Roadway Improvements Relating to Expansion Of The CIA Headquarters

ADDENDUM

CIA HEADQUARTERS EXPANSION

September 21, 1984

Figure 14
As Amended

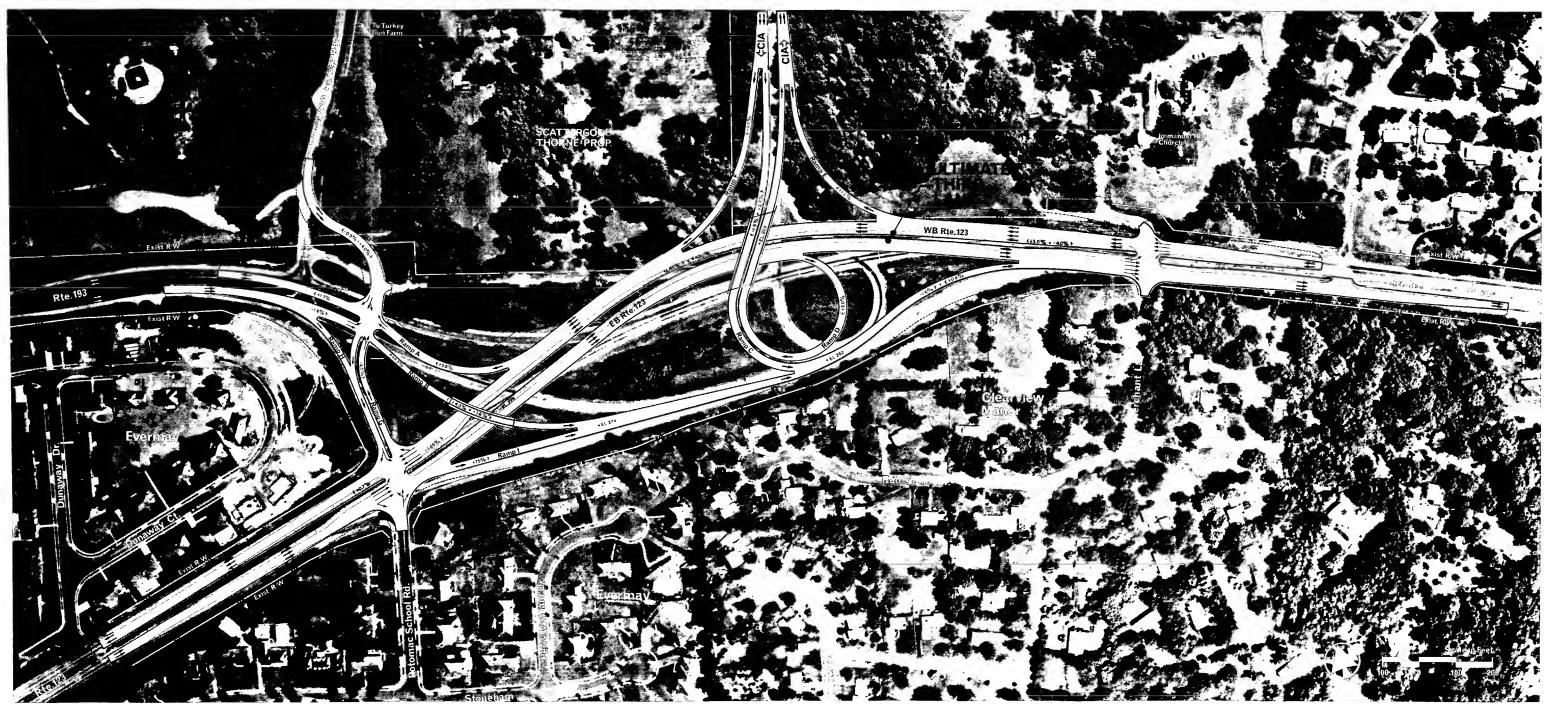
Aerial mosaics showing Alternatives 2 and 4 as they would be modified to initially defer the third lane in each direction are immediately following. As indicated, 2 thru lanes would be provided with appropriate turning lanes where necessary.

Under the terms of the Agreement between the CIA and The Virginia Department of Highways and Transportation, any significant increase in traffic volumes at the CIA access points would be cause for undertaking the widening of Route 123 to provide 3 thru lanes in each direction within the Study Area. Funds would be placed in an escrow account by the CIA to ensure that they would be available for this purpose.
